NuLu Review Overlay District (NROD)

Report to the Committee

Case No: 25-OVERLAY-0006
Classification: Non-Expedited
Meeting Date: March 5, 2025

Property Address: 620 E Market Street (622 E Market Street in LOJIC)

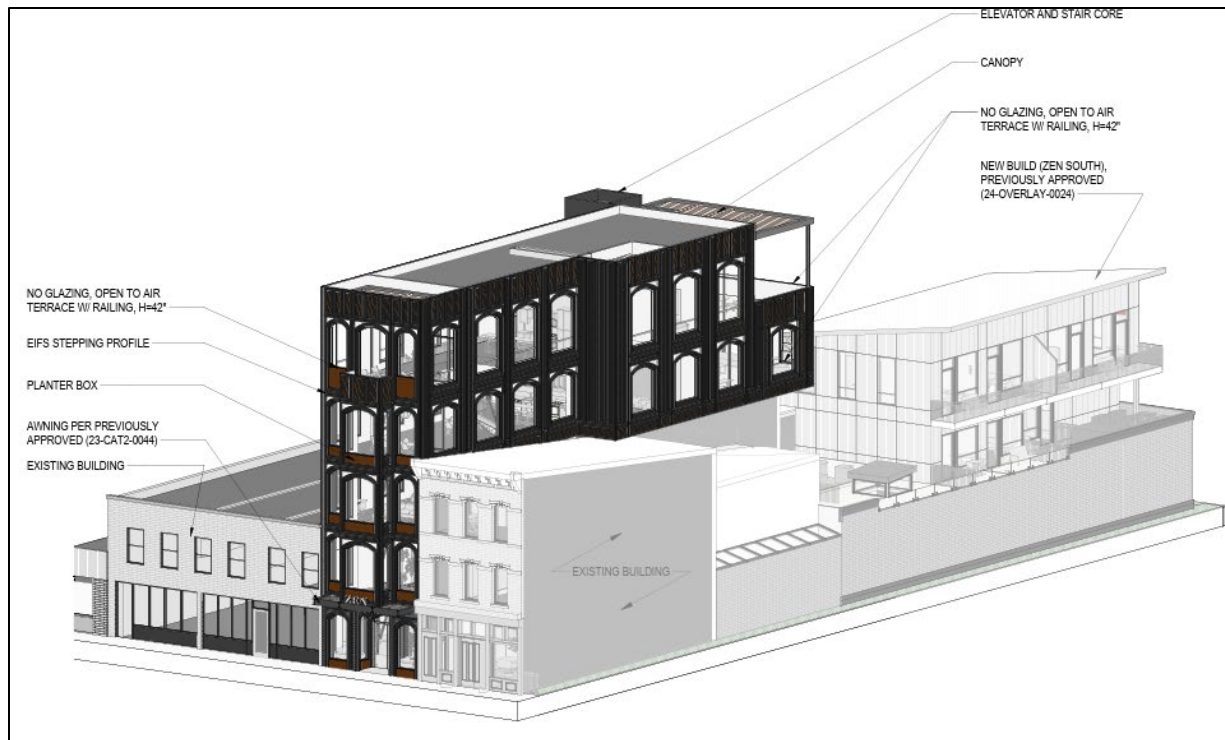
The applicant is requesting design alterations to an uncompleted building previously approved by an Overlay Permit (22-OVERLAY-0035). The façade of the new multi-story addition will be 21'-3" wide and 5 stories in height with a peak height of 67'-4". The previously approved building footprint will not be altered. The updated design of the north half of the building will include:

- The first floor of the front façade will feature a central main entry that will be approximately 10' wide and inset approximately 3' from the facade. An awning will extend over the entry. On either side of the entry, storefront glass will be approximately 5'-5' wide and flush with the adjacent buildings on either side.

- The middle of the front façade from the second to the fifth floor will project beyond the parcel line approximately 3'-0". The fifth floor portion of this wall will be a metal 3'-6" H railing around a balcony in front of an open air, covered terrace.

North and west elevation rendering

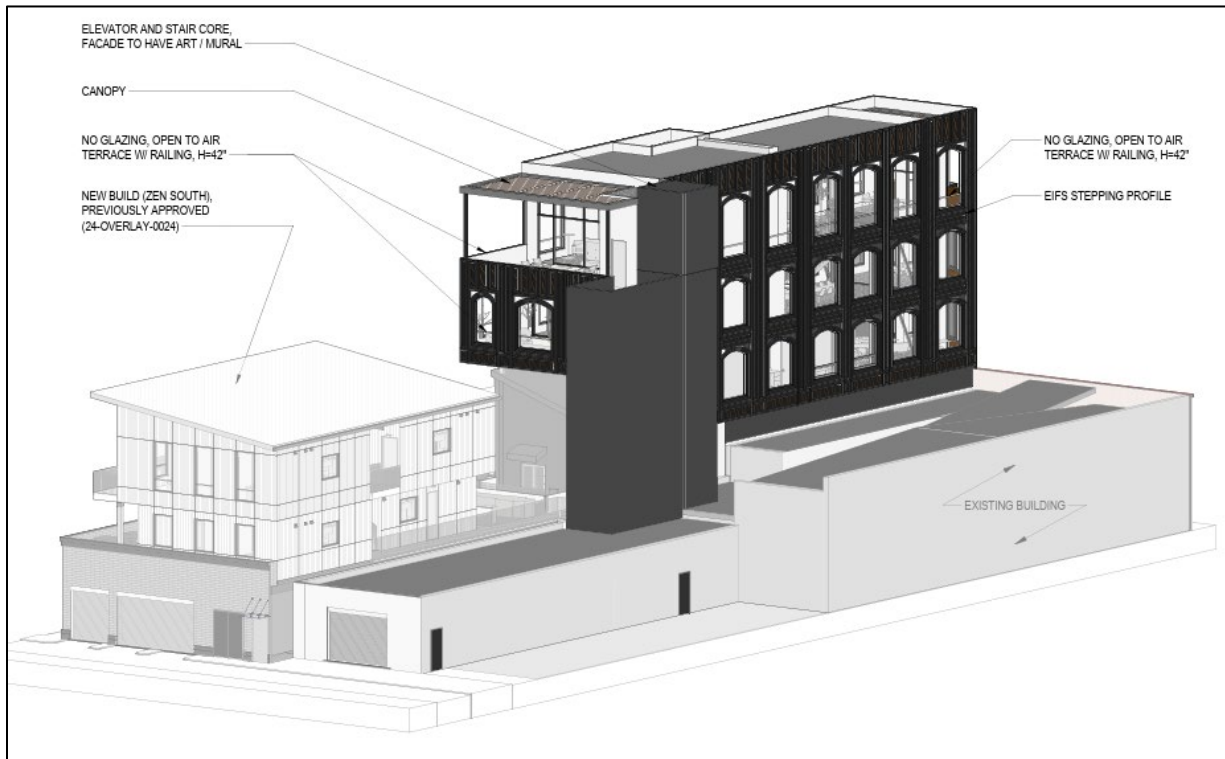
The updated design for the building is still contemporary in style and has architectural features that are common of other modern, urban projects in the District while taking cues from the historic structures as well. The brick on the ground floor, arched window details, and marble and weathered metal accents bring a level of detail often found on historic structures in the District. This mix of modern and more traditional elements will help differentiate the new portion of the building from the historic portions.

The building has a defined base at the pedestrian level. The pedestrian experience is enhanced by the building's ground level with brick, an inset entrance and large windows, and the amount of proposed window openings. Furthermore, the level of accent details is significant and helps reduce the overall mass of the addition. Other elements that promote a pedestrian-friendly environment include the building's location at the edge of sidewalk, the inclusion of a projecting bay and stepped back floors to break up the façade surface, and a front balcony on the fifth floor for an additional activity zone facing the street.

- 1. Prior to the issuance of a building permit for the subject addition, the applicant shall obtain all necessary approvals for the building to project into the right-of-way. If an encroachment permit or other approval for the proposed projected element cannot be obtained, the applicant shall submit updated plans removing the projection. Staff will review new plans to determine the level of review required.**
